Department of Planning and Zoning

MEMORANDUM

To: Development Review Board
From: Mary O'Neil, AICP, Principal Planner
Date: December 6, 2016
RE: ZP 16-1400LL

Request: Appeal of a lot line adjustment between 80 Colchester Avenue, 27 Fletcher Place and 49 Fletcher Place. (Zoning permit appealed was specifically for 80 Colchester Avenue parcel.)

SK-I

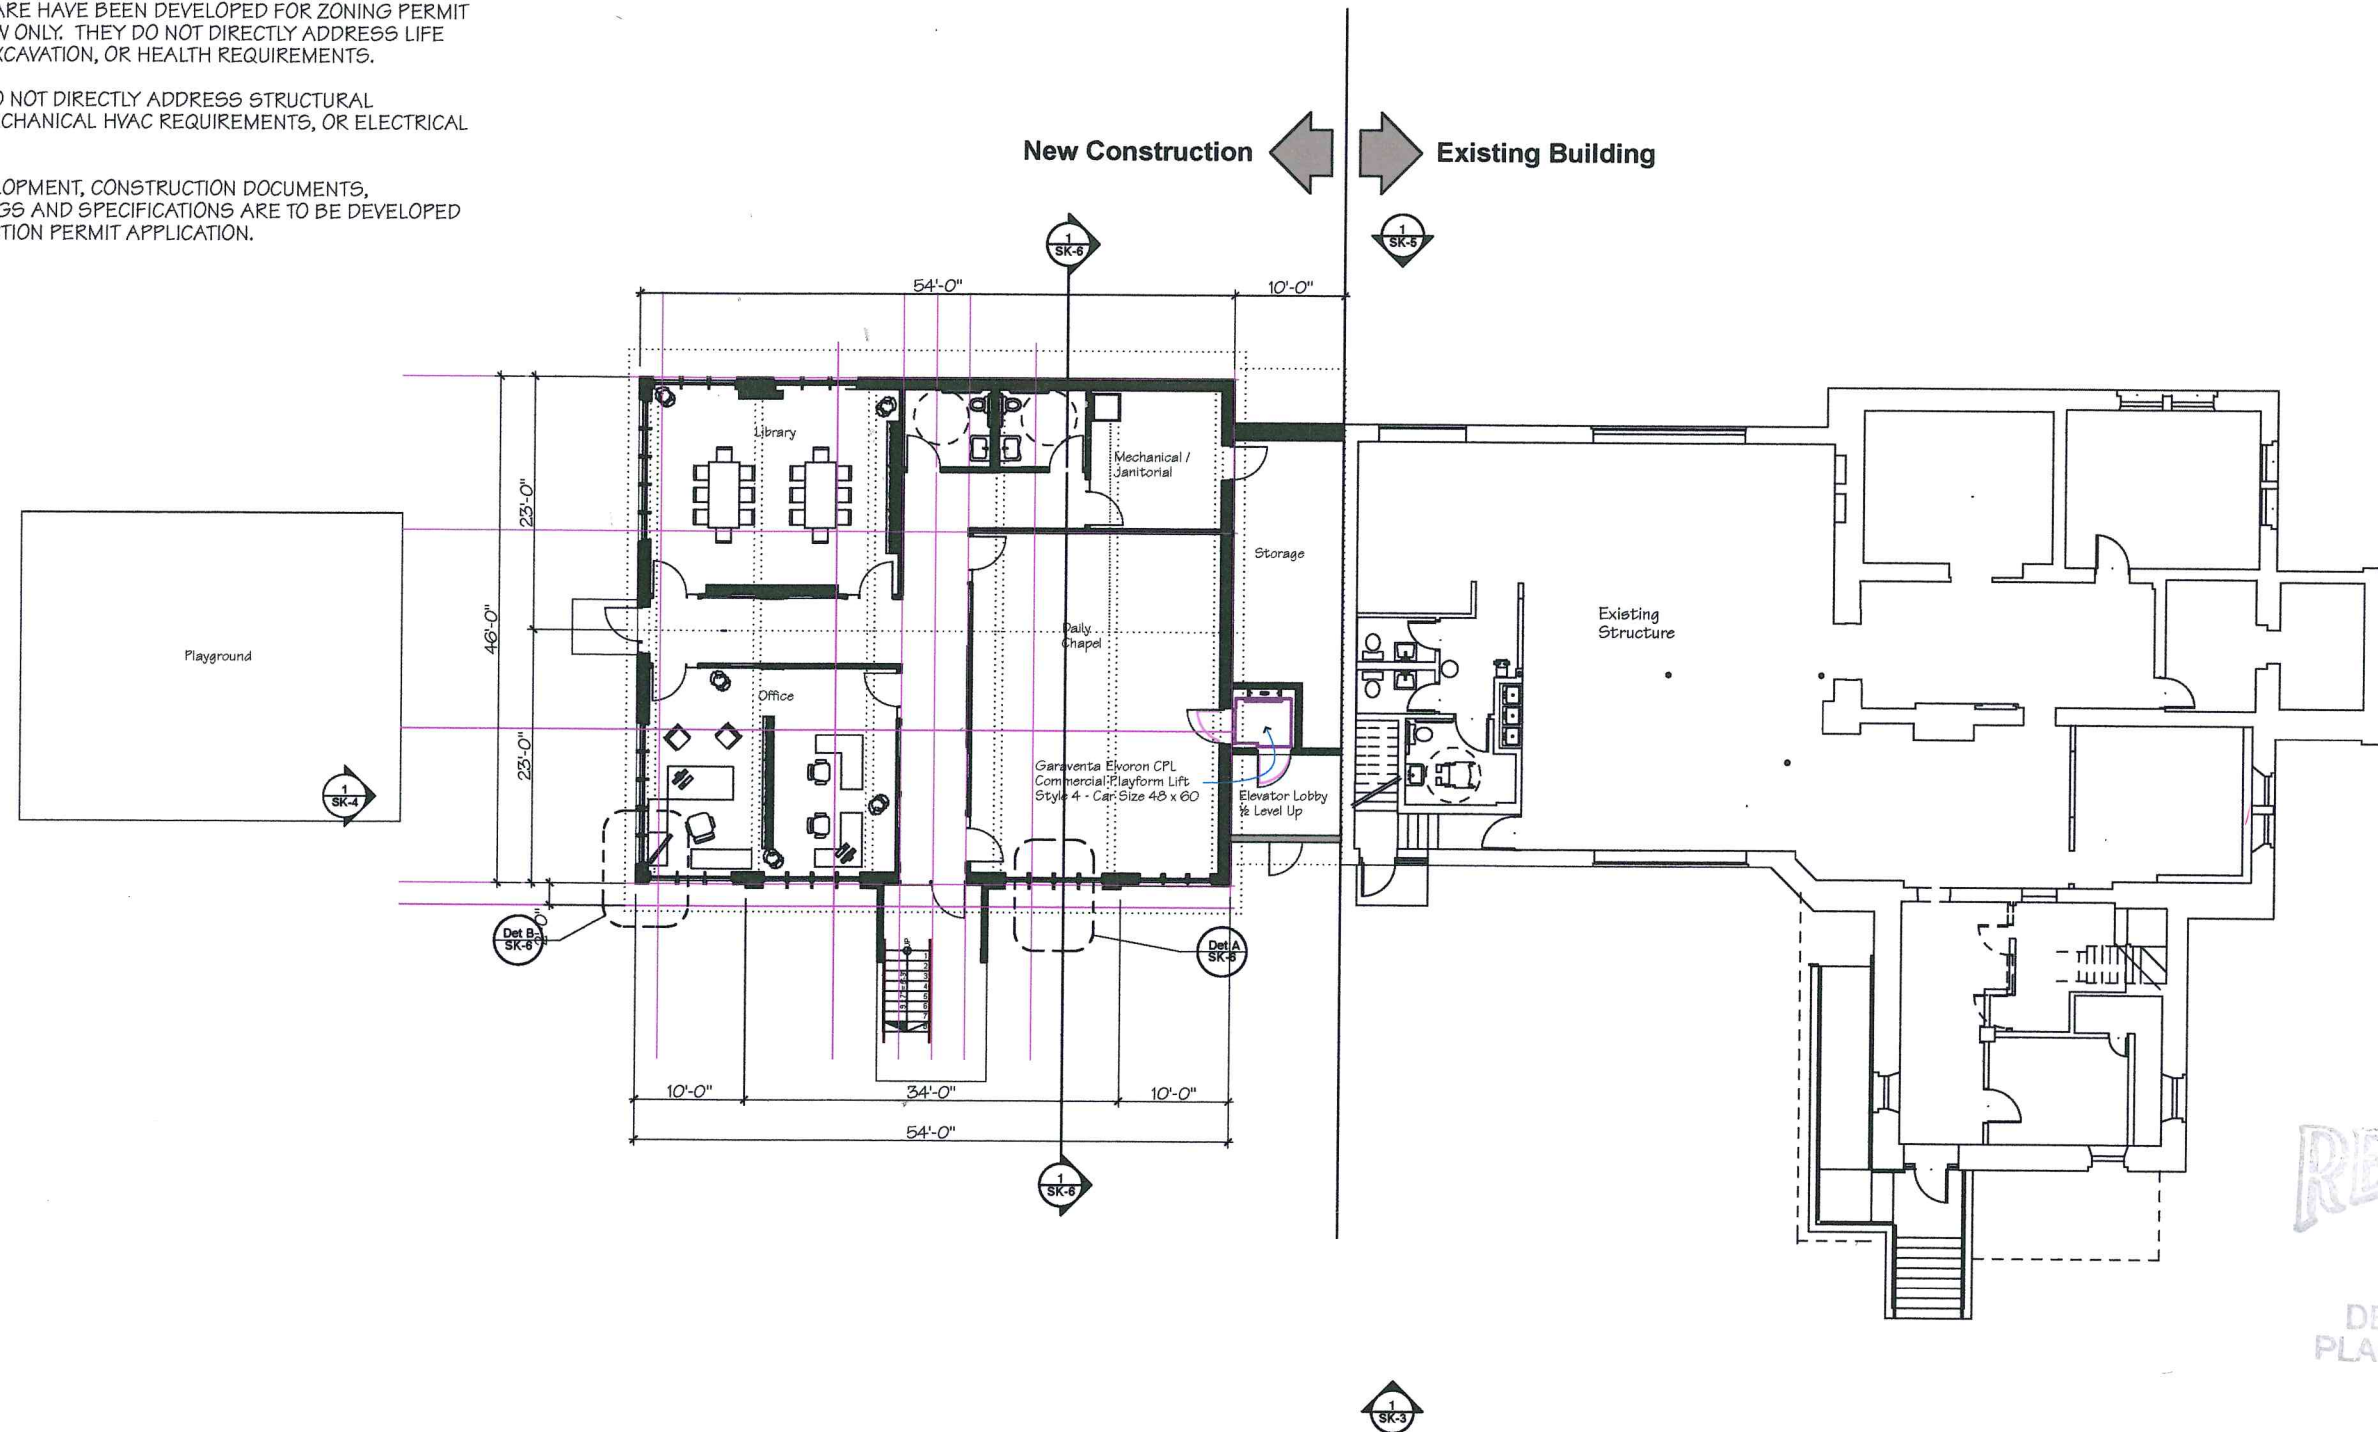
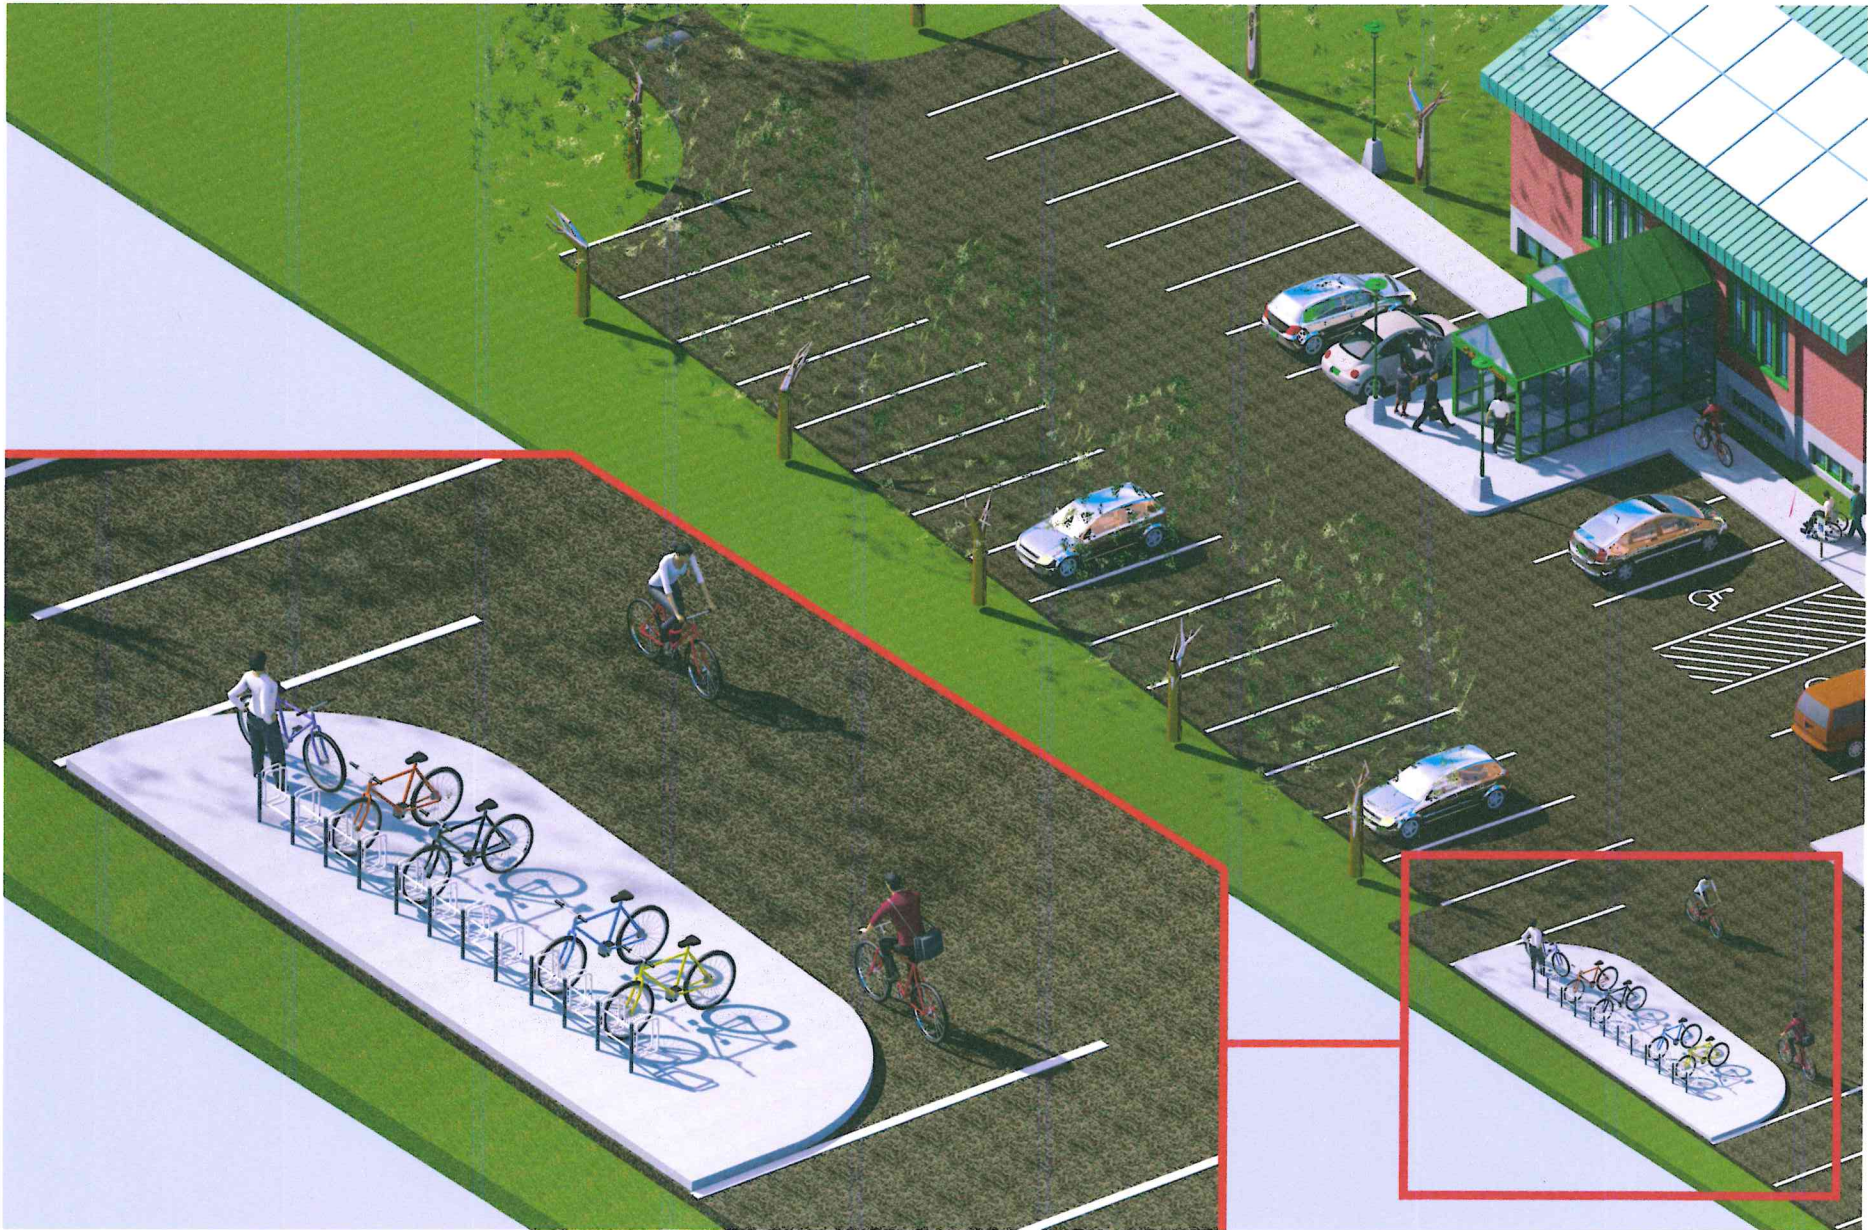
The proposed site plan (sheet C-2) and the 'Upper Level' plan (sheet SK-1) show the location of 4 proposed freestanding, outdoor area, LED light fixtures. Fixture locations are noted in front of the main entrance (2), and one each to the east and west of the main entrance, along the north side of the expanded parking area. Cutsheets have been provided for the freestanding lights, and depict acceptable cutoff lighting fixtures. Recessed lighting under the building's eaves is proposed as well, and should be adequately 'cutoff'. The freestanding lights are acceptably mounted at approximately 12'. The uniformity ratios (maximum : average illumination) are acceptable. The submittal includes a photometric plan for the freestanding lights, which shows illumination levels above the 4.0 maximum footcandle allowance in 2 locations at the front of the main entrance. However, under subsection (f), LED lighting can be considered an exception to the lighting
